1CAN041502

**SUBJECT:** Responses to Request for Additional Information  
Update the Reactor Coolant System Pressure and Temperature and the  
Low Temperature Overpressure Protection System Limits  
Arkansas Nuclear One, Unit 1  
Docket No. 50-313  
License No. DPR-51

**Response to Request for Additional Information on Reactor Coolant System  
Pressure/Temperature and Low Temperature Overpressure Protection System Limits to  
54 EFPY for Arkansas Nuclear One, Unit 1**

ANP-3300Q4-NP  
Revision 0

FIGURE 3.4.3-1  
RCS Heatup Limitations to 5431 EFPY

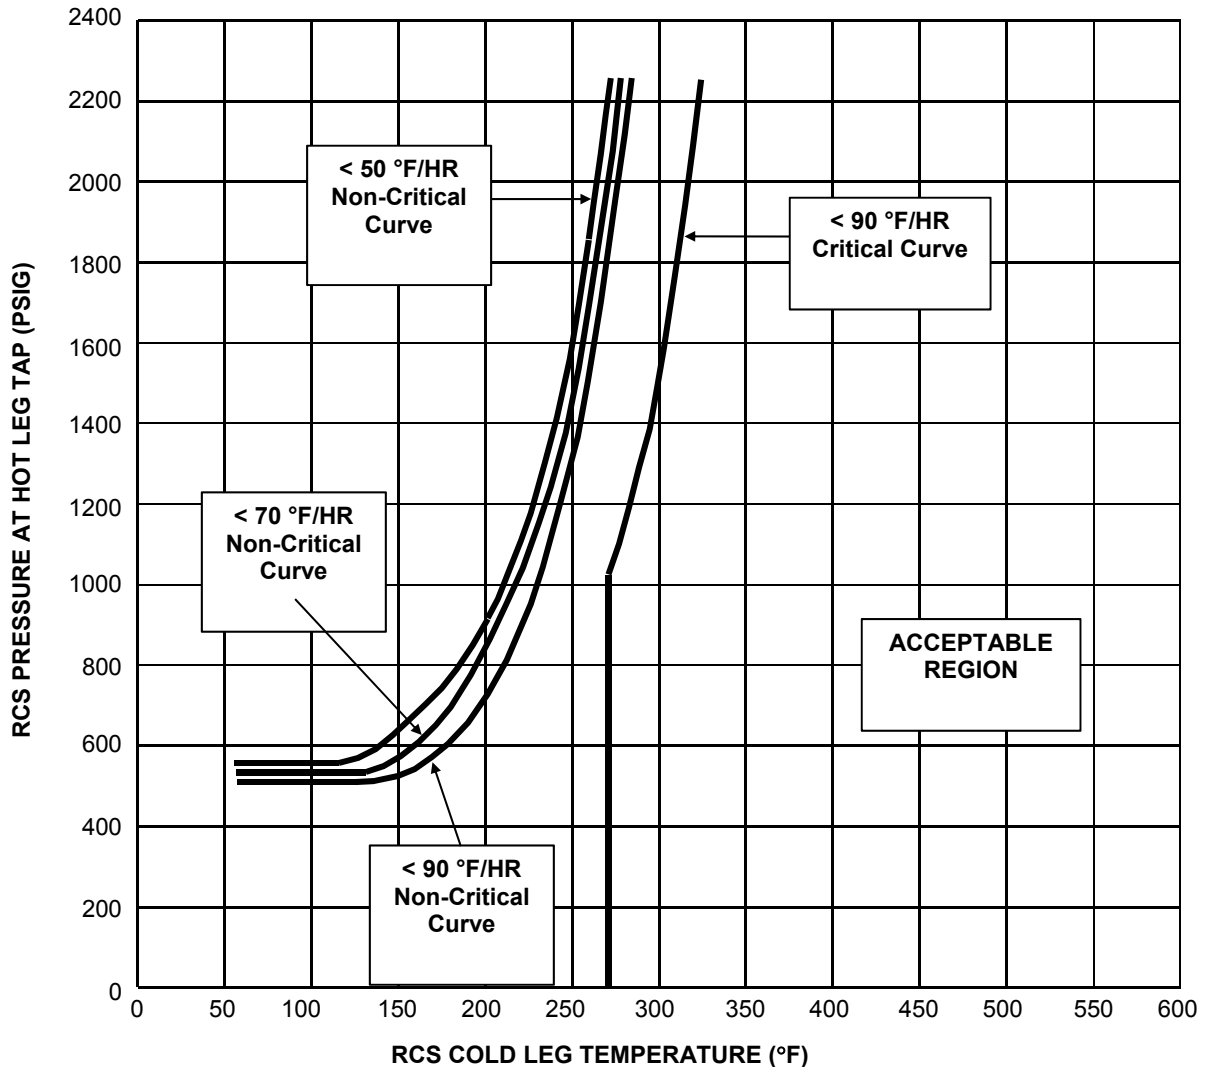
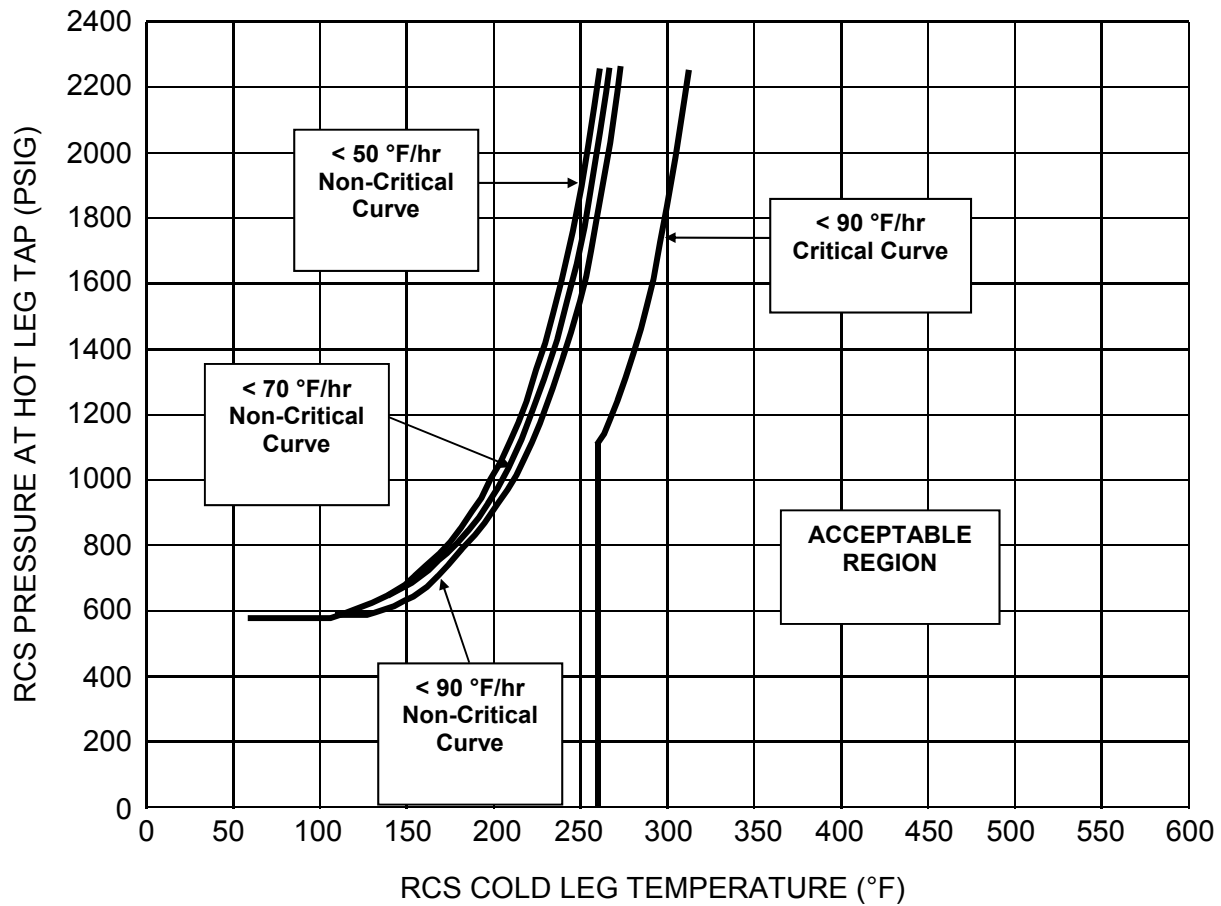
“In proposed new TS Figure 3.4.3-1, the reactor coolant pump (RCP) restrictions were modified from no RCPs allowed to be operating at < 84 deg F,  $\leq 2$  between 84 and 225 deg F and  $\leq 3$  between 225 deg F and 300 deg F to  $\leq 3$  between 100 deg F and 300 deg F and no RCPs allowed to be operating at < 100 deg F. Please provide a justification for this change, including any impacts on the limiting mass and energy analysis.”

The RCP restrictions were revised for operational considerations, not technical concerns. The revised restrictions are inputs into the supporting analyses.

Revisions to Notes 3 and 4 of the proposed TS, Figure 3.4.3-1 (RCS Heatup Limitations to 54 EFPY) are based on ANP-3300, Revision 1, Section 4.6.1, and Table 7-5. The RCP restrictions and allowable heatup rates in Notes 3 and 4 reflect the analytical input used to develop the heatup P/T curves in accordance with ASME Section XI, Appendix G, G-2215, Equation 1. As discussed in Section 1.0 above, there is an inconsistency between the description of film heat transfer coefficients used in the fracture mechanics evaluation (ANP-3300, Revision 1, Section 4.5) and the operational constraints for heatup presented in Table 7-5 (basis is limiting location pressure corrections). The inconsistency in the application of the film heat transfer coefficient was revised to accurately reflect the operational restrictions of the plant during heatup, which are correctly captured in the Note 3 and 4 definitions at 31 EFPY (TS, Figure 3.4.3-1).

The inconsistencies with ANP-3300, Revision 1 have been amended (See Section 2.5 below) such that the operating restrictions for heatup at 54 EFPY (Notes 3 and 4) are identical to the operating restrictions at 31 EFPY (Notes 3 and 4). The heatup P/T limits reported in Table 7-1 of ANP-3300, Revision 1, are not impacted by the amendment to operational restrictions. Therefore, the 54 EFPY heatup P/T limits reported in Figure 3.4.3-1 (all heatup rates) remain unchanged; Notes 3 and 4 for 54 EFPY are revised to be identical to Notes 3 and 4 for 31 EFPY as shown below. Sections 4.5, 6.0, 7.0, and Table 7-5 to ANP-3300, Revision 1 are amended to support this revision.

3. RCP Operating Restrictions:

<u>RCS TEMP</u>	<u>RCP RESTRICTIONS</u>
T > 300 °F	None
300 °F ≥ T ≥ 225 °F	≤ 3
225 °F > T ≥ 84 °F	≤ 2
T < 84 °F	No RCPs operating

4. Allowable Heatup Rates:

<u>RCS TEMP</u>	<u>H/U RATE</u>
60 °F < T ≤ 84 °F	≤ 15 °F/HR
T > 84 °F	As allowed by applicable curve

With respect to the above note changes, the LTOP P/T limits and the ERV setpoint and enable temperature are not impacted since they were generated using conservative RCP operating restrictions relative to those defined in Note 3 above. There are no changes to the limiting mass addition analysis described in Section 2.1.2.2 above.

FIGURE 3.4.3-2  
RCS Cooldown Limits to 5434 EFPY

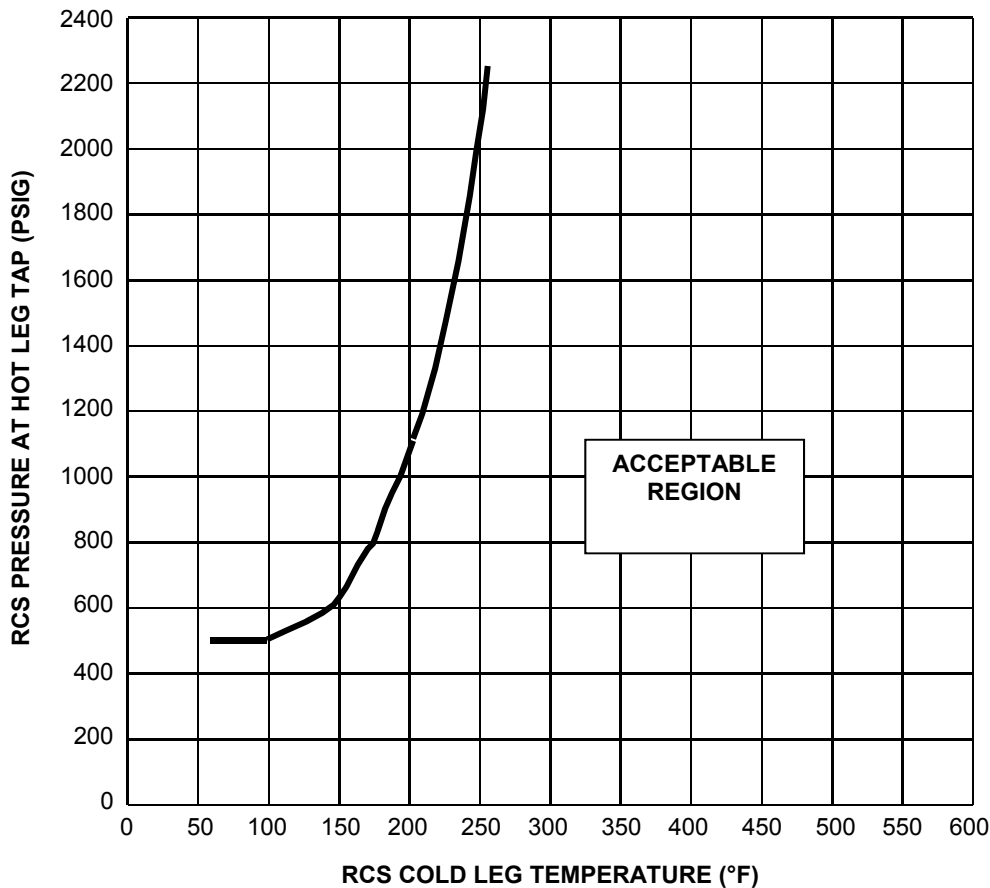
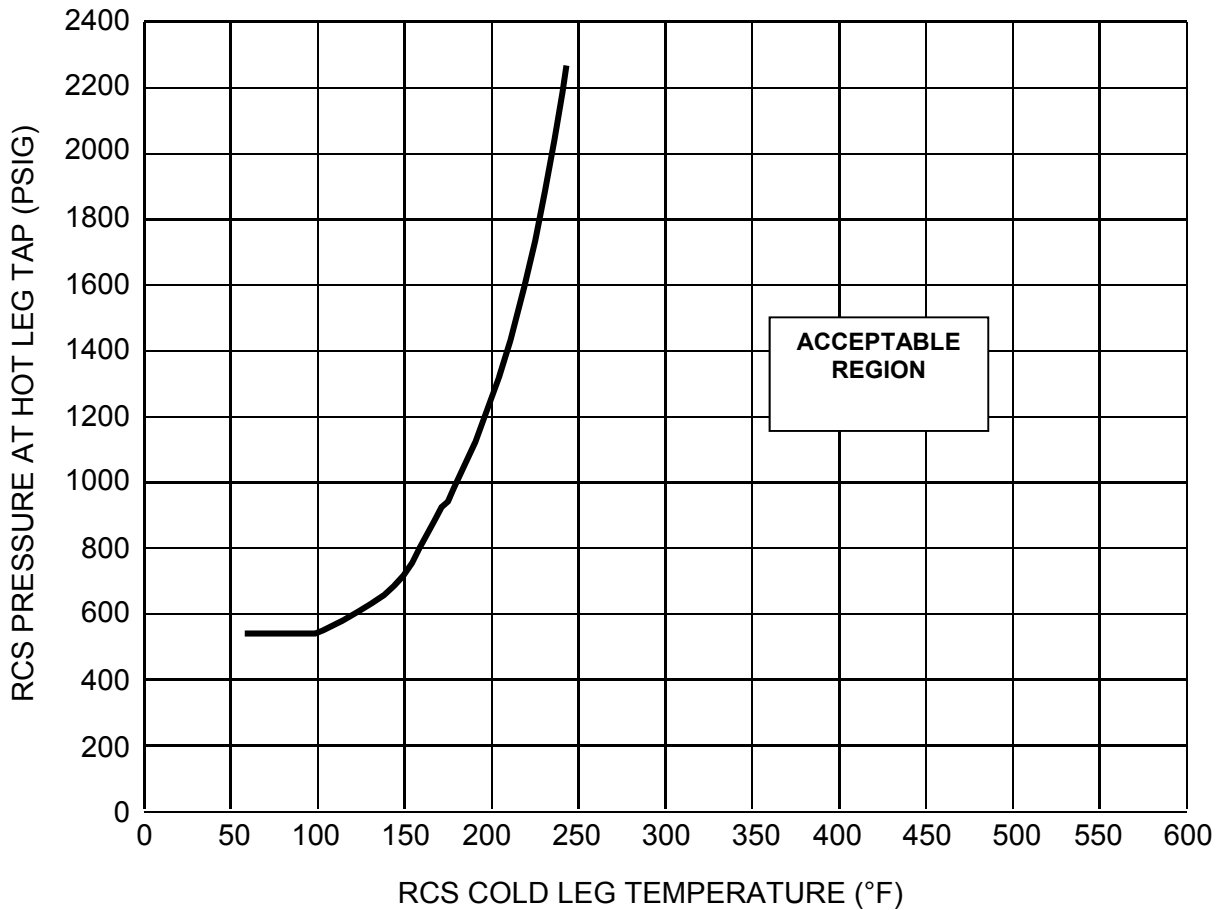
“In proposed new TS Figure 3.4.3-2, RCP restrictions were modified from no RCPs allowed to be operating at  $< 150$  deg F,  $\leq 2$  RCPs operating between 150 deg F and 255 deg F, to no RCPs operating at  $< 100$  deg F and  $\leq 2$  RCPs operating between 100 deg F and 250 deg F. In addition, Note 5 to the figure, which restricted cooldown rate to 30 deg F in 15 hours in the temperature range of 150-180 deg F was removed. Please provide a justification for these changes, including any impacts on the limiting mass and energy analysis.”

The RCP restrictions were revised for operational considerations, not technical concerns. The revised restrictions are inputs into the supporting analyses.

Revisions to Notes 3 and 4 of the proposed TS, Figure 3.4.3-2 (RCS Cooldown Limits to 54 EFPY) are based on ANP-3300, Revision 1, Section 4.6.2 and Table 7-6. The RCP restrictions and allowable cooldown rates in Notes 3 and 4 reflect the analytical input used to develop the cooldown P/T curves in accordance with ASME Section XI, Appendix G, G-2215, Equation 1. As discussed in Section 1.0 above, there is an inconsistency between the description of film heat transfer coefficients used in the fracture mechanics evaluation (ANP-3300, Revision 1, Section 4.5) and the operational constraints for cooldown presented in Table 7-6 (basis is limiting location pressure corrections). The inconsistency in the application of the film heat transfer coefficient was revised to accurately reflect the operational restrictions of the plant during cooldown, which are correctly captured in the Note 3 and 4 definitions at 31 EFPY (TS, Figure 3.4.3-2).

The inconsistencies with ANP-3300, Revision 1 have been amended (See Section 2.5 below) such that the operating restrictions for cooldown at 54 EFPY (Notes 3 and 4) are identical to the operating restrictions at 31 EFPY (Notes 3 and 4). The cooldown P/T limits reported in Table 7-3 of ANP-3300, Revision 1, are not impacted by the amendment to operational restrictions. Therefore, the 54 EFPY cooldown P/T limits reported in Figure 3.4.3-2 remain unchanged, with the exception of the elimination of Note 5.

Note 5 was included for 31 EFPY to cover the acid reducing phase cooldown transient where the last RCPs are assumed operating at temperatures below 200 °F. For this cooldown case, the supporting P/T limit analysis was performed such that the RCS cooldown between 150 °F and 180 °F is assumed to occur over 15 hours. Note 5 is eliminated for the updated 54 EFPY P/T limit analysis since for the last RCP trip cases analyzed in the supporting analysis, the cooldown ramp rates and step changes as defined in the TS under allowable cooldown rates is being maintained over the entire temperature range of the normal cooldown. See Section 2.5 below and the revisions to ANP-3300, Revision 1, Section 4.6.2 for further information.

Notes 3 and 4 for 54 EFPY are revised to be identical to Notes 3 and 4 for 31 EFPY as shown below, with the exception of elimination of Note 5. Sections 4.5, 4.6.2, 6.0, 7.0, and Table 7-6 to ANP-3300, Revision 1 are amended in Section 2.4 below to support this revision.

<u>RCS TEMP</u>	<u>RCP RESTRICTIONS</u>
T > 255 °F	None
150 °F ≤ T ≤ 255 °F	≤ 2 ( <del>See Note 5</del> )
T < 150 °F	No RCPs operating

<u>RCS TEMP</u>	<u>C/D RATE</u>	<u>STEP CHANGE</u>
T ≥ 280 °F	100 °F/HR	≤ 50 °F in any 1/2 HR
280 °F > T ≥ 150 °F	50 °F/HR ( <del>Note 5</del> )	≤ 25 °F in any 1/2 HR
T < 150 °F	25 °F/HR	≤ 25 °F in any 1 HR

~~5. If RCPs are operated < 200°F, then the RCS cooldown rate from 150°F < T < 180°F is reduced to 30°F in 15 hours.~~

With respect to the above noted changes, the LTOP P/T limits, ERV setpoint and enable temperature are not impacted since they were generated using conservative RCP operating restrictions relative to those defined in Note 3 above.
